ADDENDUM NO.: 3.0

DATE OF ADDENDUM: October 29, 2014

**Founders Hall Renovations for Allied Health and Nursing
Naugatuck Valley Community College, Waterbury, Connecticut
BI – CTC – 442 – CMR**

SKETCH NO.
 AD3-SK-EP1.1B-1

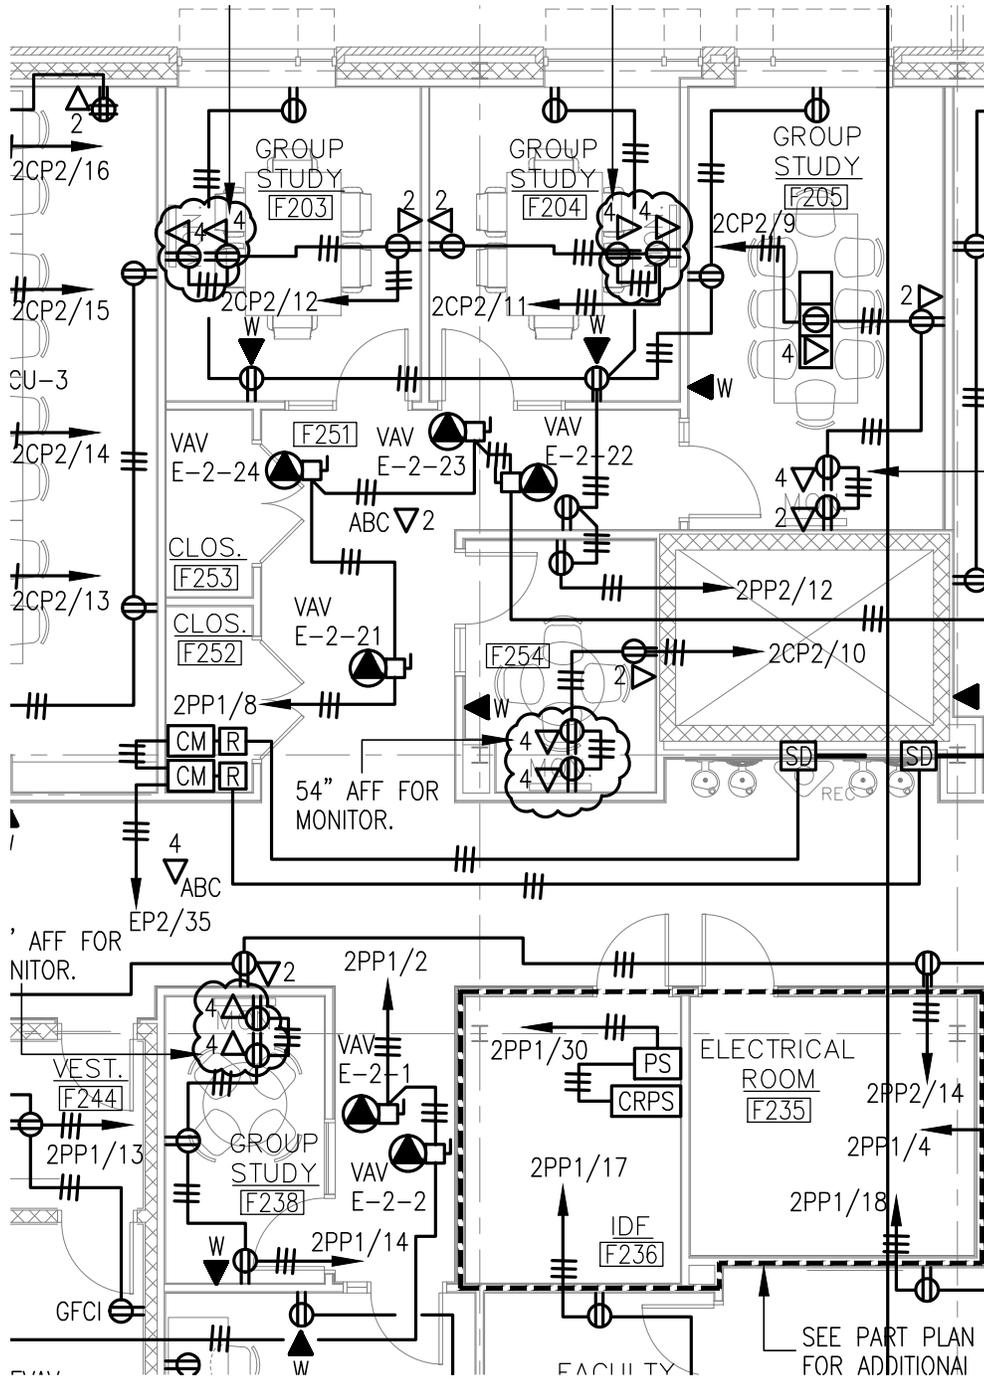
DRAWING EP1.1B – MAIN LEVEL FLOOR POWER PLAN – NORTH: **REVISE** miscellaneous power/data items in Conference F130 per attached sketch AD3-SK-EP1.1B-1.

SKETCH NO.
 AD3-SK-EP1.2B-6

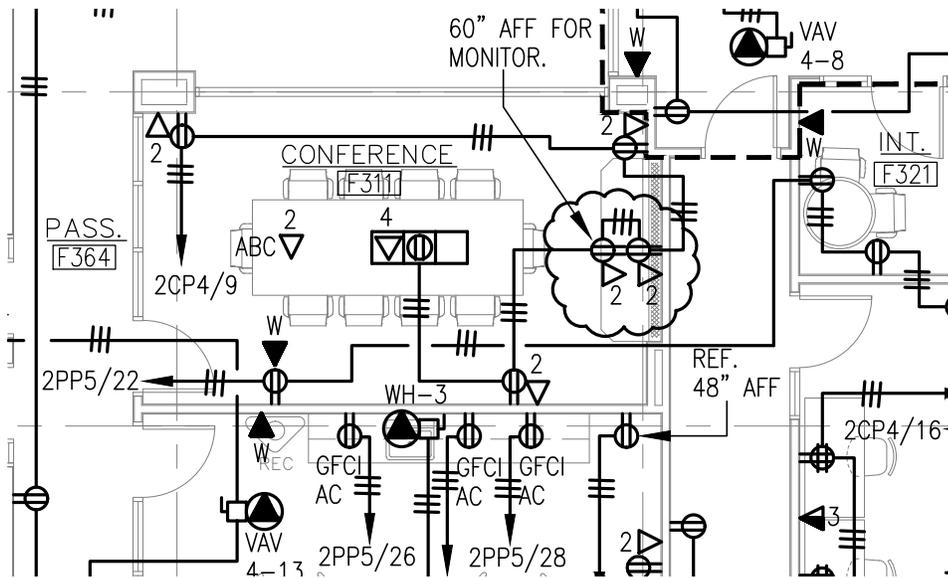
- a. At Part Plan of Room F213 and F214 **ADD** data/electrical outlets to west wall of Diagnostic Lab F213 to coordinate with headwall detail 2/A11.17.
- b. At Computer Lab F202 **ADD** data/electrical outlets above counter in northeast corner.
- c. **REVISE** miscellaneous power/data items in Group Study rooms per attached sketch AD3-SK-EP1.2B-1.
- d. **REVISE** data items in PT Class Lab F207 per attached sketch AD3-SK-EP1.2B-2.
- e. **REVISE** data items in Mobility Lab F208 per attached sketch AD3-SK-EP1.2B-3.
- f. **REVISE** miscellaneous power/data items per attached sketch AD3-SK-EP1.2B-4.
- g. **REVISE** power/data items in Ultrasound Lab F216 per attached sketch AD3-SK-EP1.2B-5.
- h. At Part Plan of Room F213 and F214 **ADD** data outlet for camera and additional x-ray notification light above eastern door into Control F214 per attached sketch AD3-SK-EP1.2B-6.

SKETCH NO.
 AD3-SK-EP1.3A-1

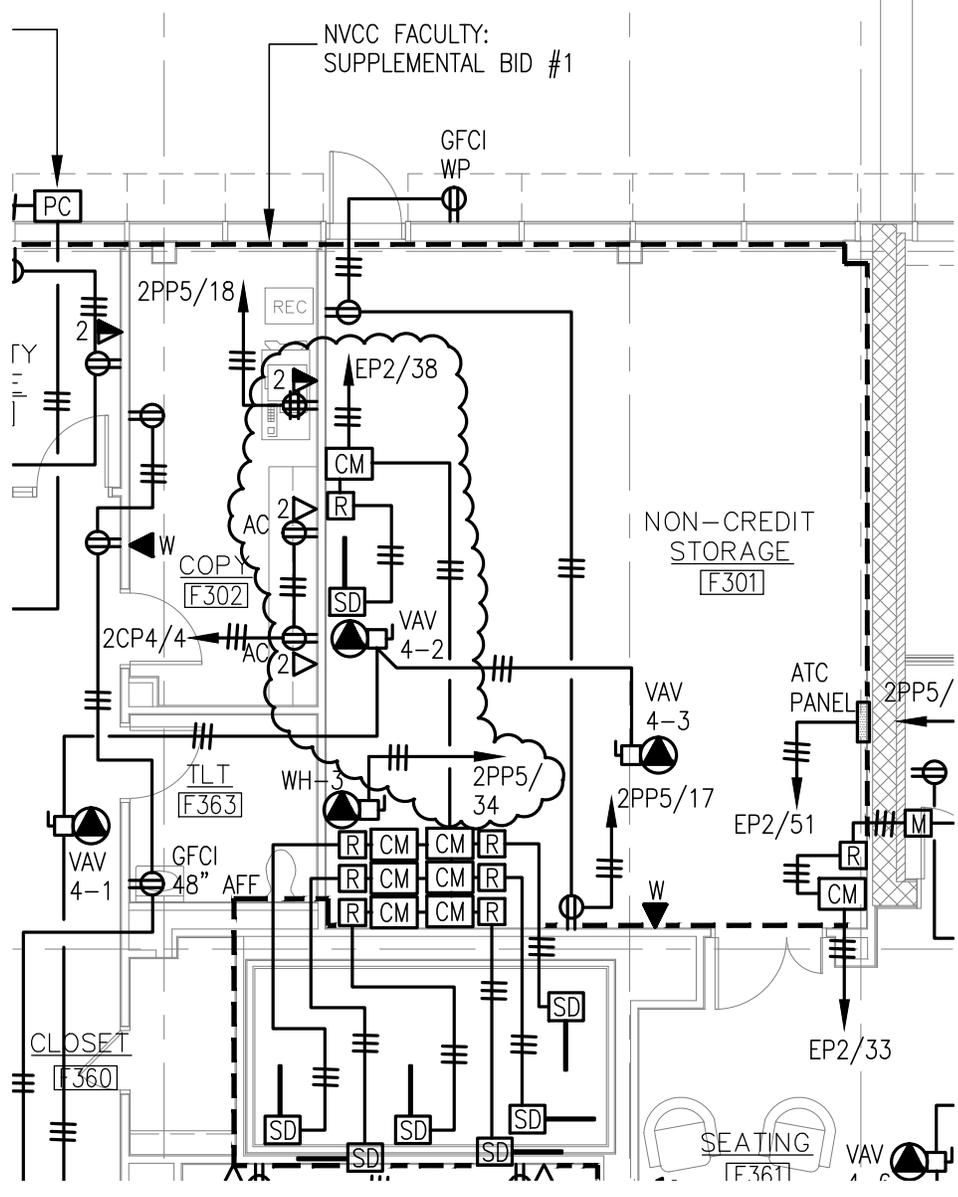
- a. **REVISE** power/data items in Conference F311 per attached sketch AD3-SK-EP1.3A-1.
- b. **REVISE** miscellaneous power/data items in Non-Credit Storage F301 per attached sketch AD3-SK-EP1.3A-2.
- c. **REVISE** power/data items in Conference F327 per attached sketch AD3-SK-EP1.3A-3.

SKETCH NO.
 AD3-SK-EP1.3B-1

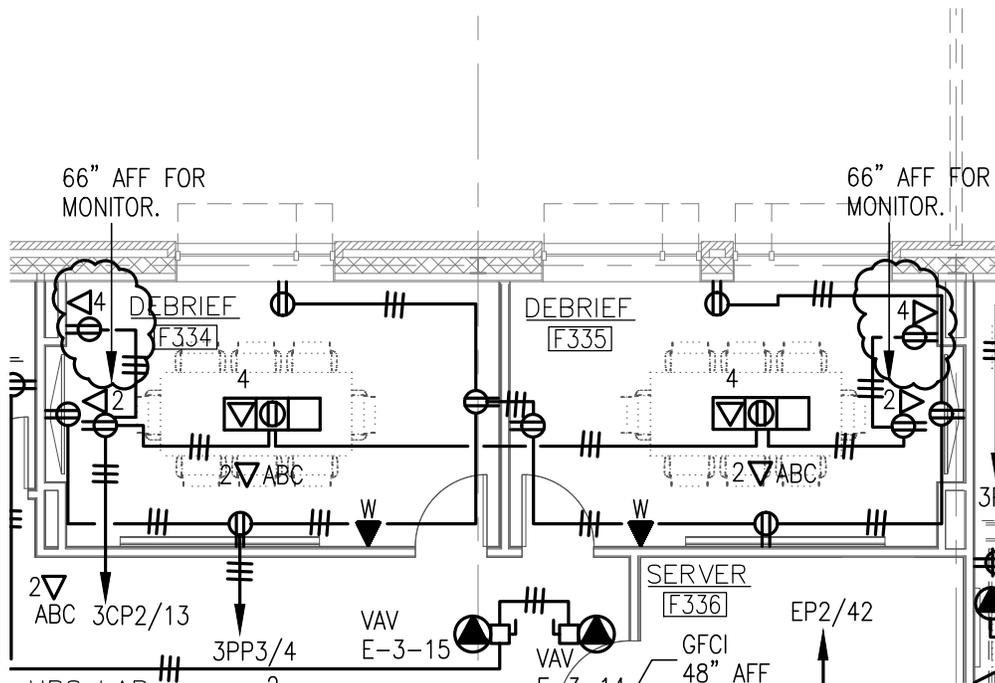
- a. **REVISE** power/data items in HPS Labs per attached sketch AD3-SK-EP1.3B-1.
- b. **REVISE** power/data items in Debrief rooms per attached sketch AD3-SK-EP1.3B-2.

SKETCH NO.
 AD3-SK-EP1.3B-3

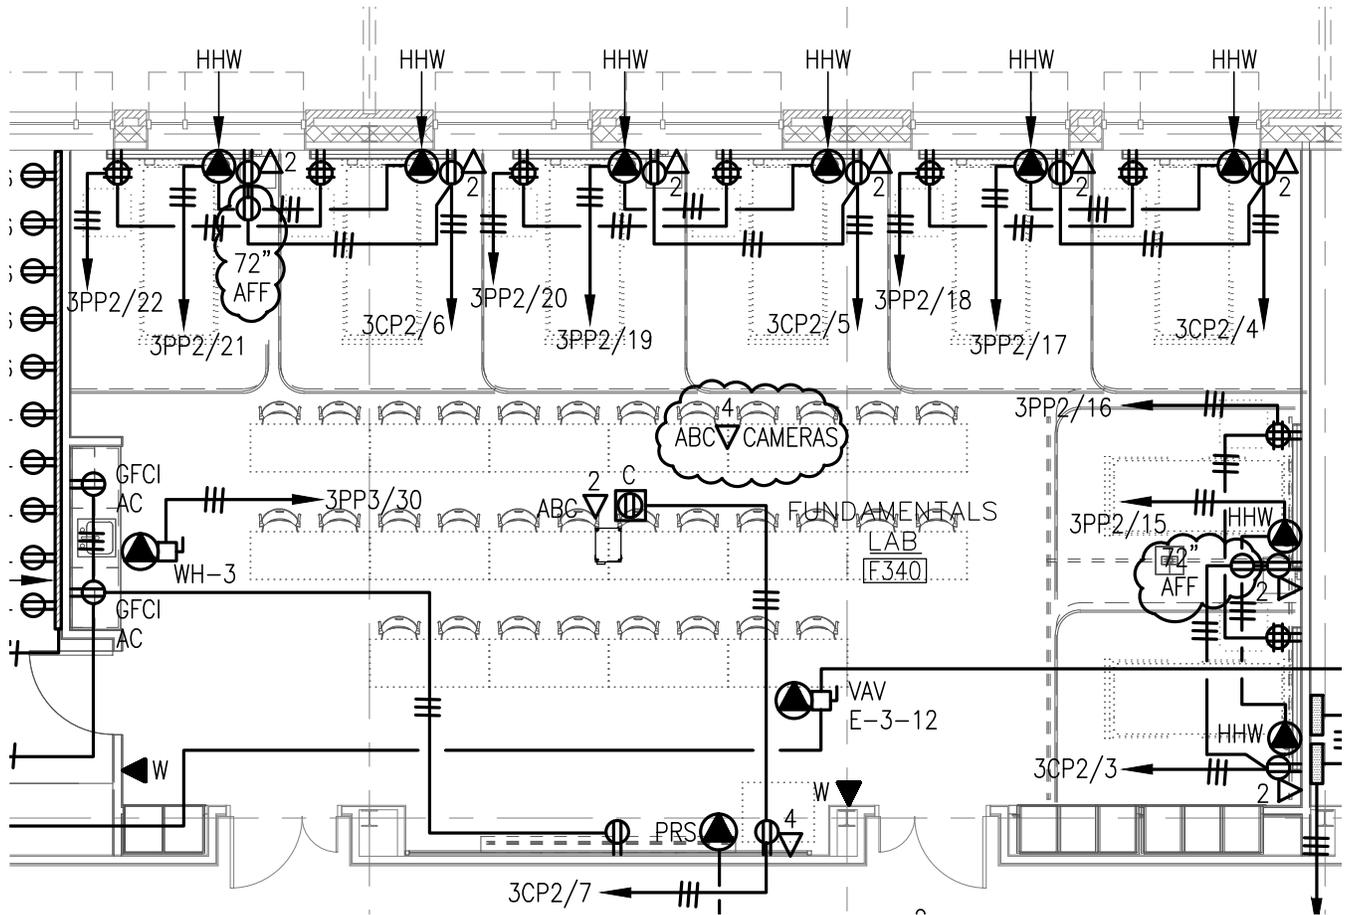
- c. **REVISE** power/data items in Fundamentals Lab F338 per attached sketch AD3-SK-EP1.3B-3.
- d. **REVISE** power/data items in Fundamentals Lab F340 per attached sketch AD3-SK-EP1.3B-4.

SKETCH NO.
 AD3-SK-EP1.3B-5

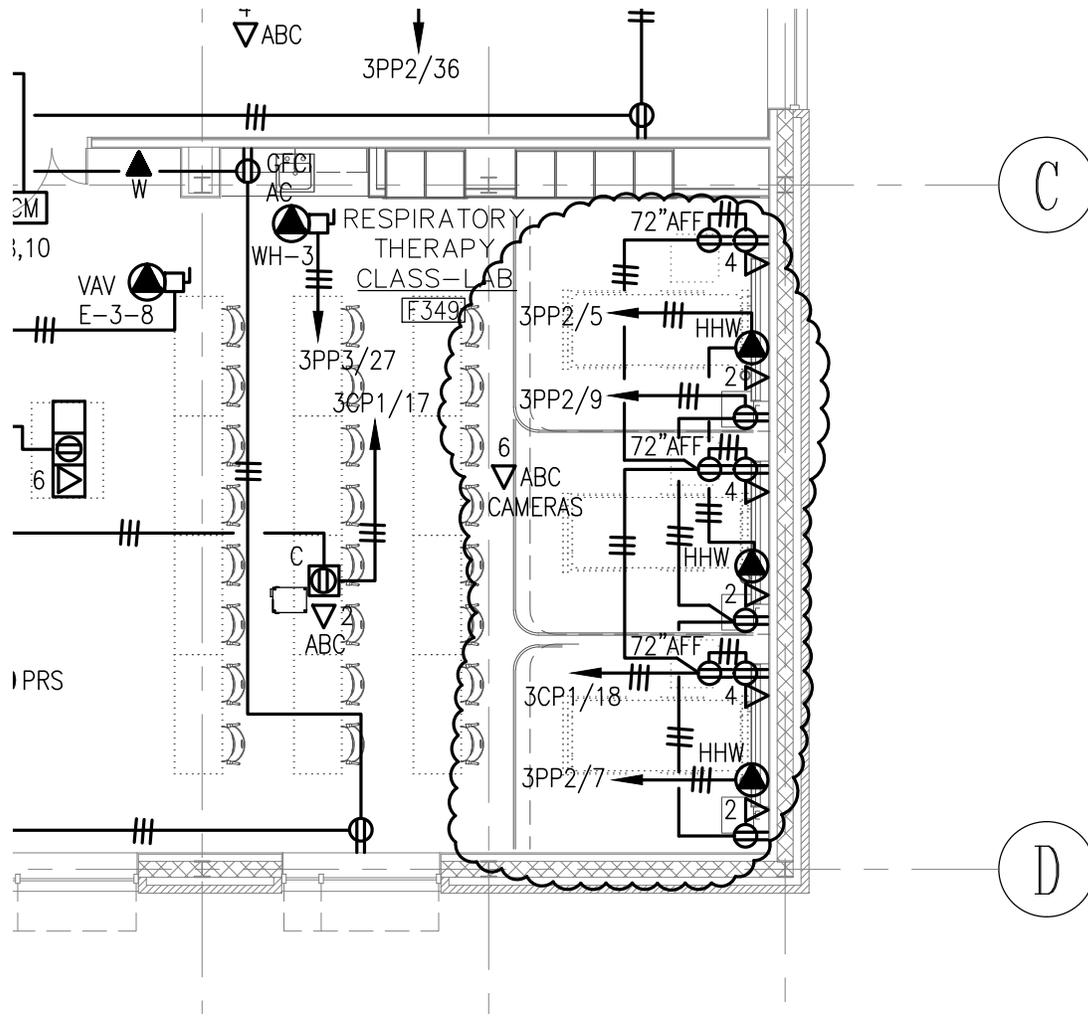
- e. **REVISE** miscellaneous power/data items per attached sketch AD3-SK-EP1.3B-5.
- f. **REVISE** power/data items in Respiratory Therapy Class-Lab F349 per attached sketch AD3-SK-EP1.3B-6.

SKETCH NO.
 AD3-SK-EP1.3B-7

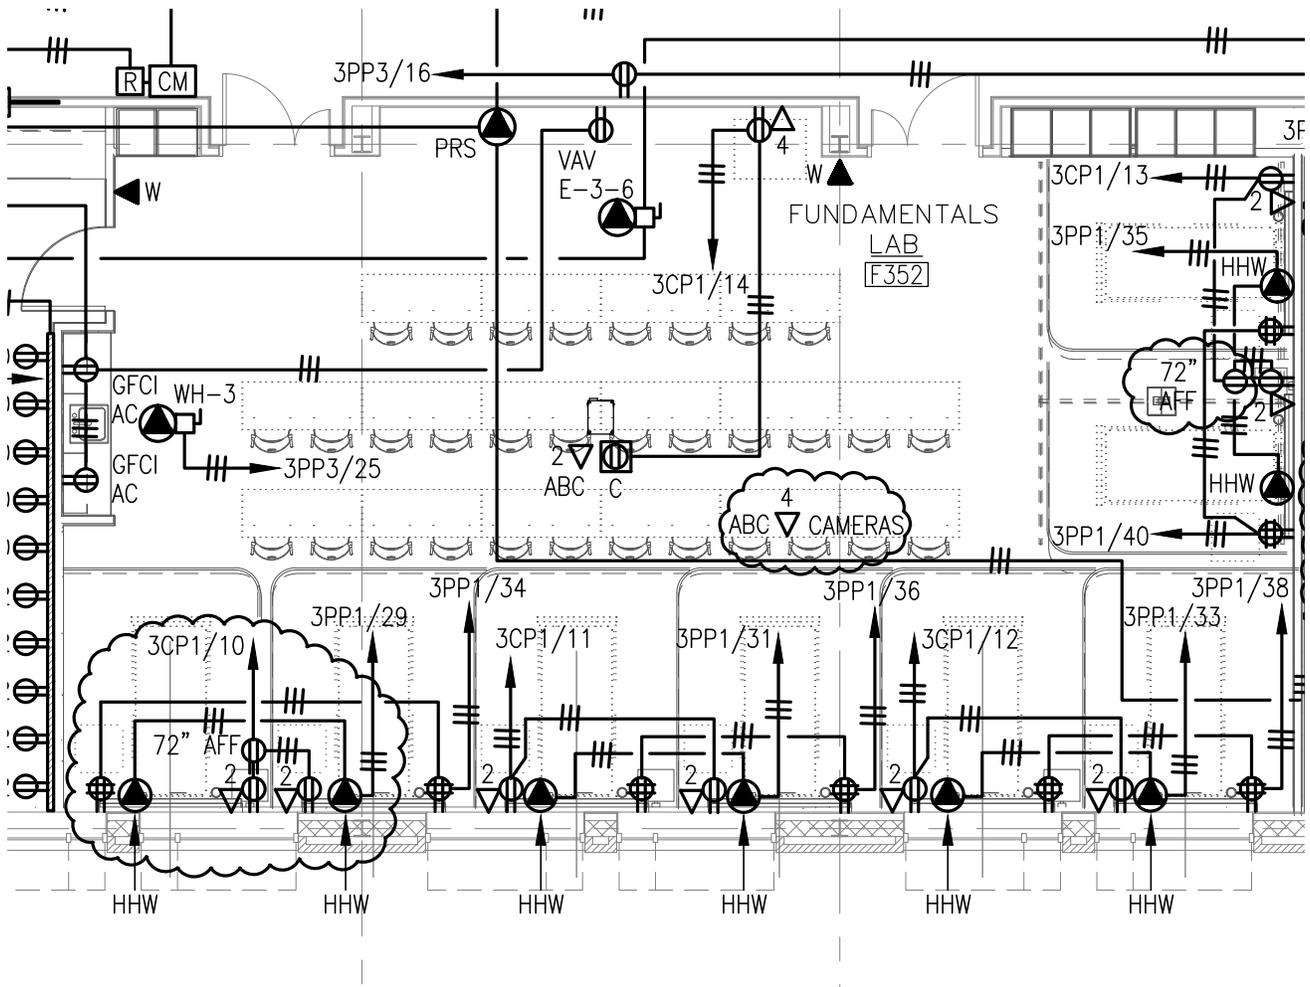
- g. **REVISE** power/data items in Respiratory Therapy Lab F351 per attached sketch AD3-SK-EP1.3B-7.
- h. **REVISE** power/data items in Fundamentals Lab F352 per attached sketch AD3-SK-EP1.3B-8.

SKETCH NO.
AD3-SK-EP1.3B-9

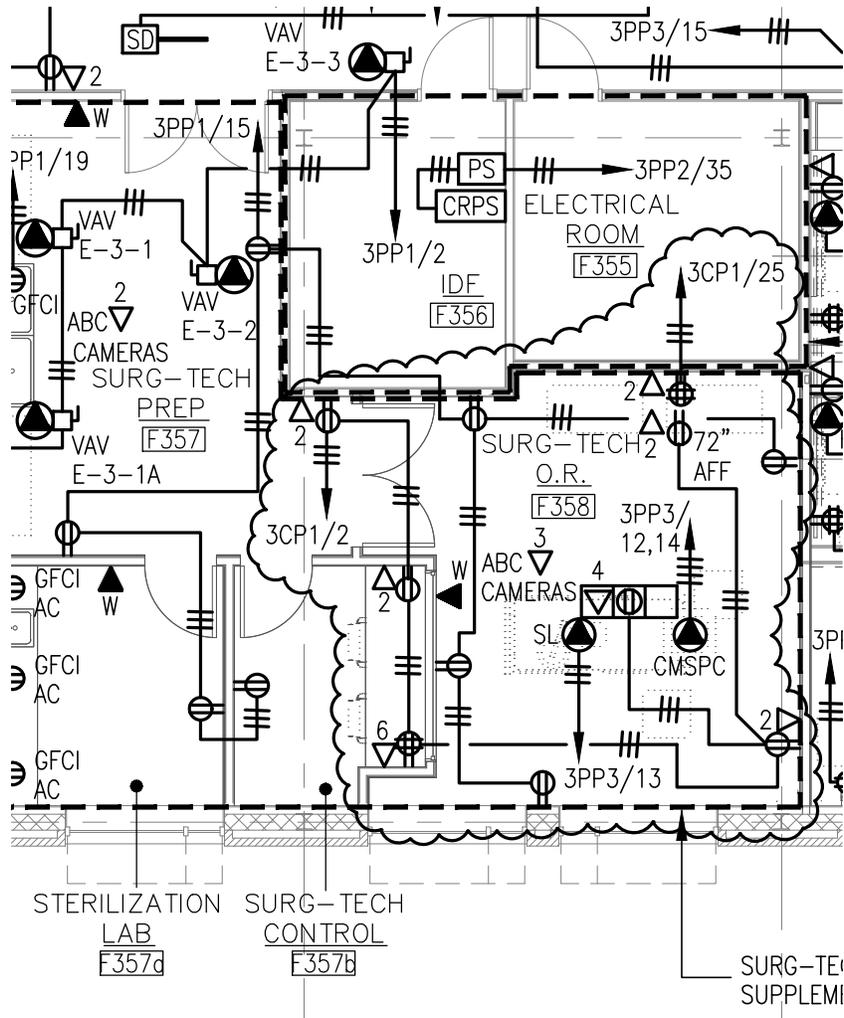
- i. **REVISE** power/data items in Fundamentals Lab F354 per attached sketch AD3-SK-EP1.3B-9.
- j. **REVISE** power/data items in Surg-Tech O.R. F358 for Supplemental Bid #3 per attached sketch AD3-SK-EP1.3B-10.
